Office Action Summary	Application No. 10/566,696	Applicant(s) LUCAS, BERND	
	Examiner OMAR HIJAZ	Art Unit 3633

DETAILED ACTION

This communication is a first Office Action Non-Final rejection on the merits.

FIGURE 10A

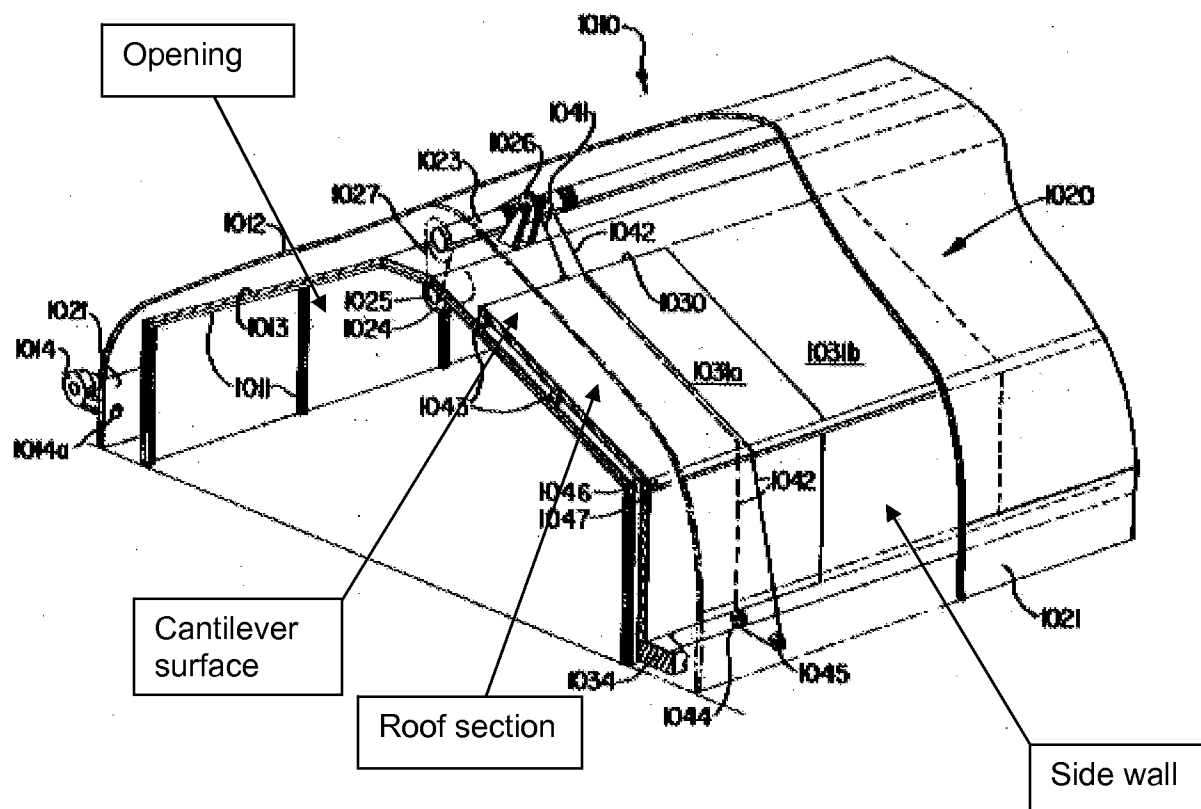
As per claim 1, Green et al. teaches a housing or enclosure (building; abstract), comprising end walls (it is construed that a building enclosure comprises walls) and side walls (side walls or blanket; figure 10A below) that can be opened and closed at least partially (the blanket moves from a retracted position to an extended position; abstract), as well as roof sections (roof sections; figure 10A below), for wherein at least one of the side walls is formed as a hanging (blanket; abstract) that can be wound up at the bottom end and that is kept ready (blanket is stored in a folded form in storage box 1021 at the bottom; col. 11, lines 66-67) and can be raised and lowered (col. 11, lines 35-44) by an end bar (leading edge 1030) guided on both ends (as illustrated, both ends of the hanging blanket are supported; figure 10), which at least partially forms a roof section in a closed state (as illustrated, the hanging blanket forms a roof section; figure 10), and the hanging is fixed to hang directed towards at least one side wall (figure 10A below).

As per claim 2, Green et al. teaches the end bar comprises a guided region (as illustrated, the bar is guided along the paths of ropes 1042) and at least one freely projecting cantilever region (cantilever surface; figure 10A below).

As per claim 3, Green et al. teaches the free edge of an outwardly pointing cantilever surface (cantilever surface; figure 10A below) pivots outwards (figure 10A below).

As per claim 17, Green et al. teaches at least one of the end walls has a seal opening (opening; figure 10A below), which reaches up to the housing roof (figure 10A below) and which continues into a closable roof section opening (roof section; figure 10A below) and wherein the end bar has a cantilever surface (cantilever surface; figure 10A below) at least partially closing and opening the roof section opening (as illustrated the roof section is capable of being partially closed; figure 10A below).

bottom; col. 11, lines 66-67) and a raising and lowering end bar (leading edge 1030; col. 11, lines 35-44), which is guided on both ends thereof and keeps the hanging ready (as illustrated, both ends of the hanging blanket are supported; figure 10), wherein the end bar forms at least partially a roof section in a closed state (as illustrated, the hanging blanket forms a roof section; figure 10), and the hanging is fixed to hang towards at least one side wall of the housing or enclosure (figure 10A below).
